Groundwater Application Review Summary Form

Application # G- 18877

PUBLIC INTEREST REVIEW FOR GROUNDWATER APPLICATIONS

TO: Water Rights Section
 FROM: Groundwater Section Travis Brown
 Reviewer's Name
 SUBJECT: Application G- 18877 Supersedes review of _____
 Date January 29, 2020
 Date of Review(s)

Hydrographs

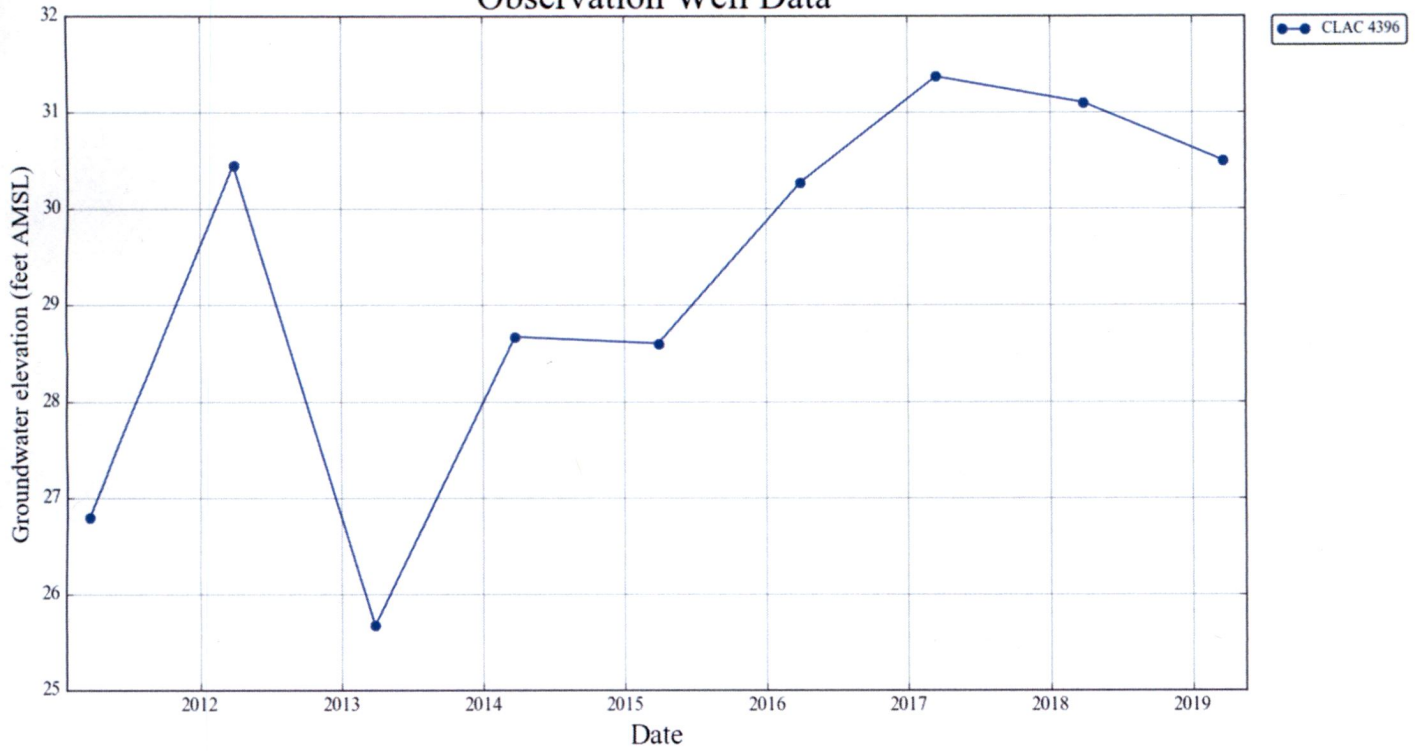
Water availability data for the CRBG aquifer(s) in the area of the proposed POA is very limited. There is one well with relevant reported water level observations: CLAC 4396, ~1.2 miles west of the proposed POA. A hydrograph of reported water levels from CLAC 4396 does not show persistent declines over the period of record, 2011-2019 (see attached Hydrograph). Reported static water levels and well completion depths for wells greater than 350 ft in total depth in the Sections surrounding the proposed POA do not indicate progressive declines in static water levels or deepening well completion depths (see attached Well Statistics).

Well Statistics

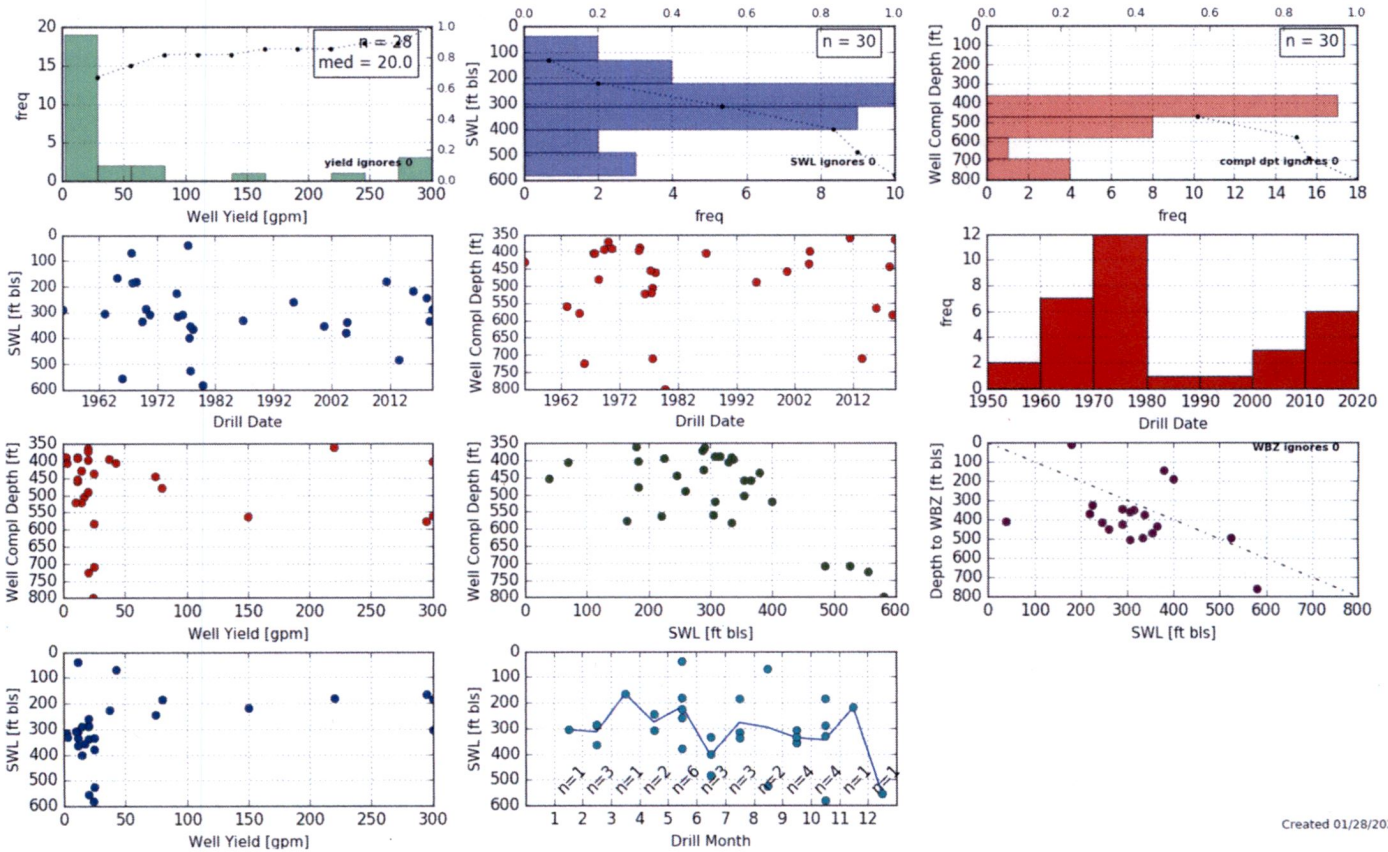
Basis for aquifer confinement evaluation: Static water level reported on the well log for the proposed POA (CLAC 67911) at the time of completion (180 ft bls on 5/16/2011) is above the applicable water-bearing zone in the basalt (~339-361 ft bls), indicating confined conditions. Comparison of reported static water levels to depth to water-bearing zones from well logs deeper than 350 ft in the surrounding Sections similarly indicates confined conditions (see attached Well Statistics).
